## INFRASTRUCTURE – HIGHWAYS

### **LAND DEVELOPMENT RI2IM-mod(Kendal)**

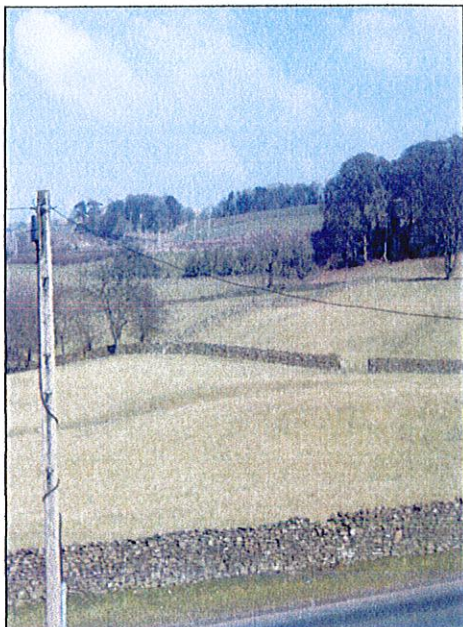
Going up Oak Tree. Bad in winter. Existing parking problems. Cars come up the road and round the first bend across the central reservation. This area does not clear easily of ice and snow. Additional problems caused by the cut-off to the right and allowing access to nos. 2-10 Oak Tree Road.

Top of Oak Tree Road. Outside 30, 28, 26, 47, 45, 43, 41, 39, 37, 35, 33, 31. Currently illegal parking on both sides of the pavement. It is often impossible for cars to pass if not. Blind bends outside 30 and 26 Oak Tree Road not captured here. You often have to drive in the other direction in order to avoid problems.

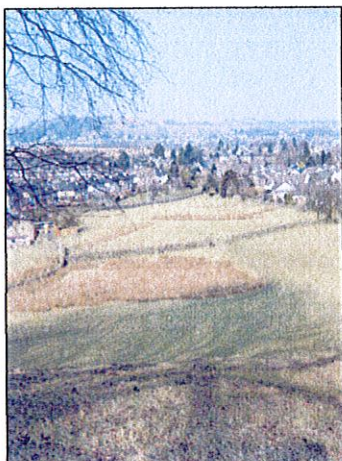
R56 and R141 – seen as you look up from Castle Green Road. This is a far more logical picture than AECOM's. The site boundary will probably go diagonally from the second tall tree above the top of the field, through the gap between the fields and to the semi-break in the wall at the bottom. There will be one or two roads across it. This photo helps to highlight the rise in height and the quality of the landscape. In planning terms R141 should not be split up!  
Taken from the top house on Castle Green Road.

R56 and R141 - the fields destined to have roads across them. This photo helps one to appreciate the heights involved, the proximity of the reed beds and the great-crested newt colony.
